Follow-up Questions for COA/CC Applicant on 5/15/23 Submission to Planning Board

WAYLAND COUNCIL ON AGING / COMMUNITY CENTER
MUOD Design Guidelines March 14, 2023

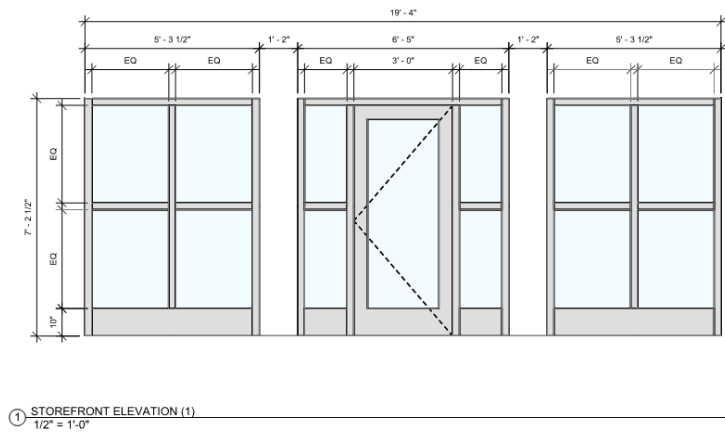
- **The May 16, 2023 letter from K. Treacy to Town Planner R. Hummel speaks of “windows and French doors” being made of fiberglass. Is fiberglass the glazing material or is it the framing?**

Fiberglass is the material of the framing. The glazing will be clear tempered glass.
